<b>Location:</b>	<b>2201 Valley Street</b> <b>(See map on reverse)</b>
<b>Assessor's Parcel Numbers:</b>	<b>008-0658-009-01 &amp; -010-00</b>
<b>Proposal:</b>	Design Review discussion for a proposed development that would include a new 450 tall office building including approximately 760,000 square feet of office.
<b>Applicant:</b>	Denise Pinkston / TMG Partners
<b>Owners:</b>	BA1 2201 Valley LLC & Mash Petroleum
<b>Planning Permits Required:</b>	Regular Design Review for new construction, Major Conditional Use Permit for development exceeding 200,000 square feet and 250 feet in height, and Minor Variances for loading berths (6 required; 3 proposed) and tower dimensional regulations.
<b>General Plan:</b>	Central Business District
<b>Zoning:</b>	CBD-P / Height Area 6
<b>Environmental Determination:</b>	Determination Pending
<b>Historic Status:</b>	Not a historic property
<b>City Council District:</b>	3

# 2201 Valley

## Creative Office Building

## 03 - 28 - 2018 HEARING

## PARKING SCREEN COMPARISON

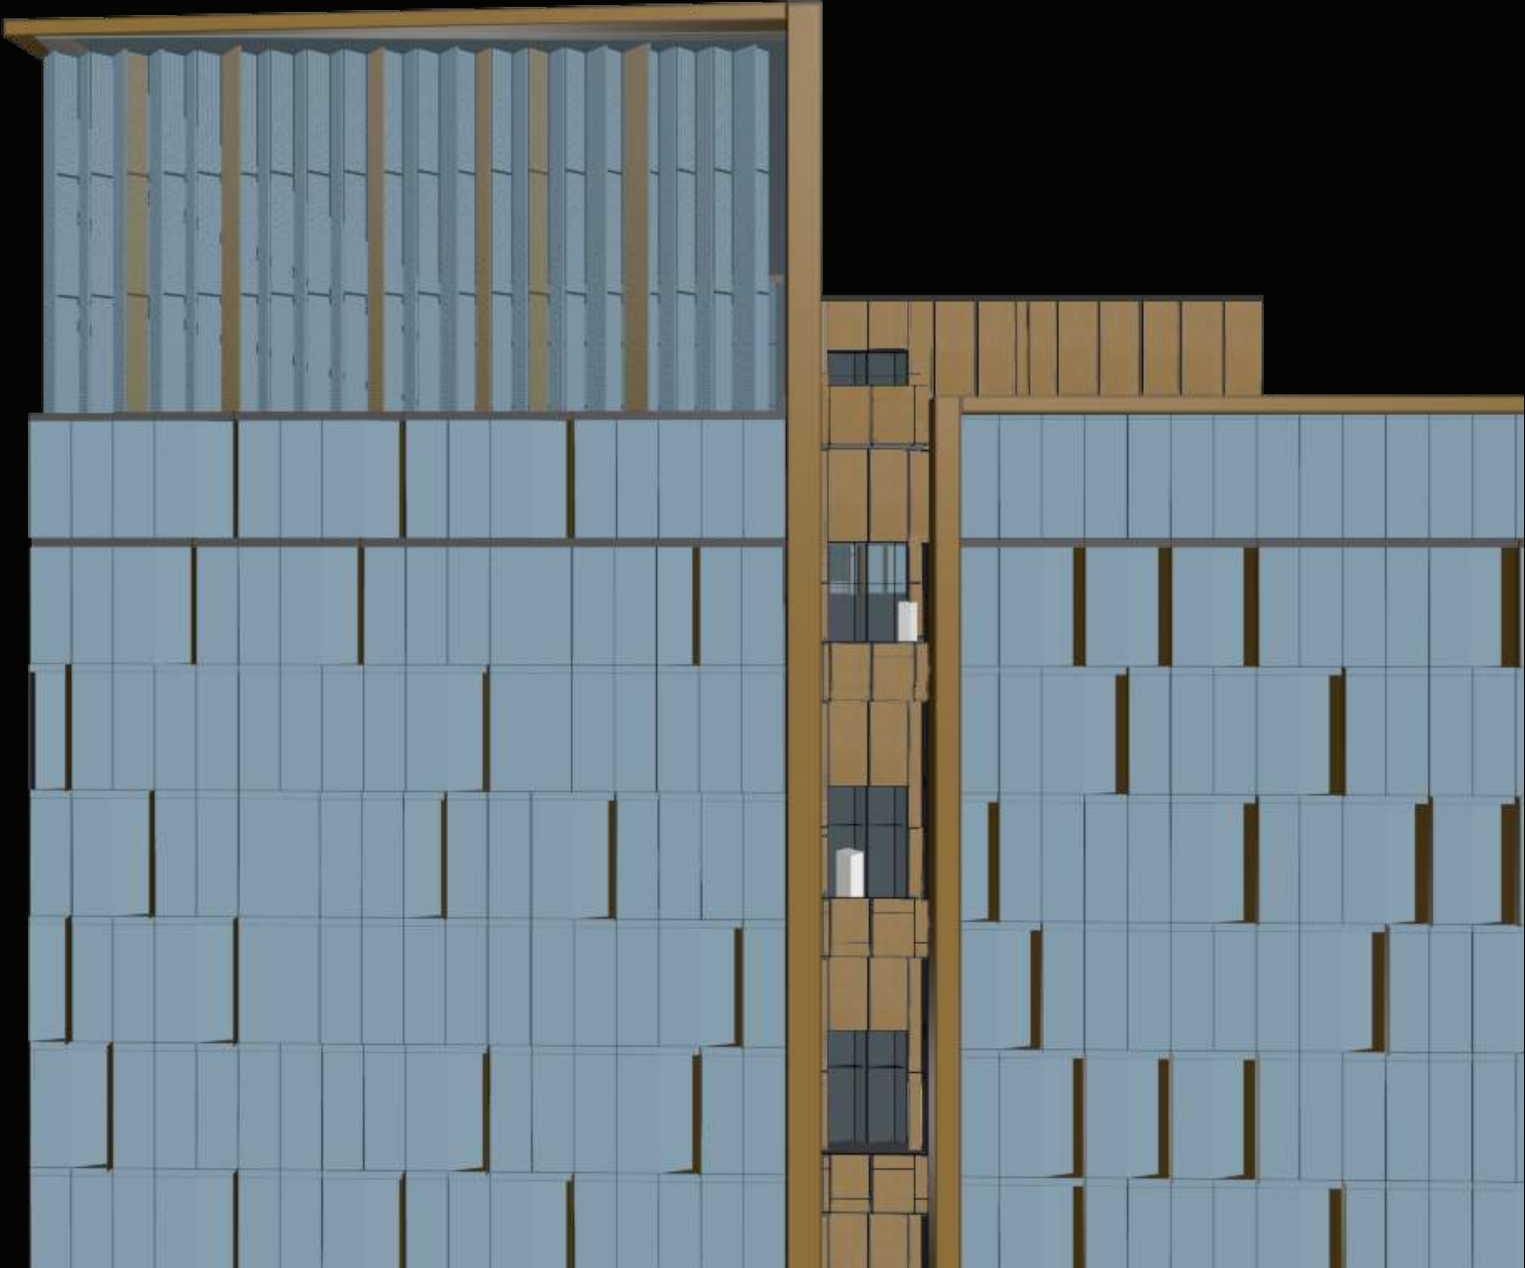
The proposed project includes three full parking garage levels above the ground floor, which is proposed to be screened by a perforated metal cladding system along the Telegraph side of the building, and further screened by a glass curtain wall system along the Valley Street side of the project. Staff had raised concerns about the location of the screening for garage ventilation and had recommended that more of the open screening be located off the main street facades. The applicant has submitted revisions that refine the screening on the garage to demonstrate how the proposal would be able to screen vehicles from view from the exterior of the building and are proposing to incorporate a public art component into the screening area. Staff requests that the DRC review and comment on this approach, and would also recommend that if this approach is accepted that the public art component be completely defined prior to consideration by the Planning Commission.

- \* Eliminate visibility of the cars
- \* Artistic expression on the panel screens
- \* Angled panels giving texture and rythm while ties to the tower above and the crown
- \* 50% natural ventilation
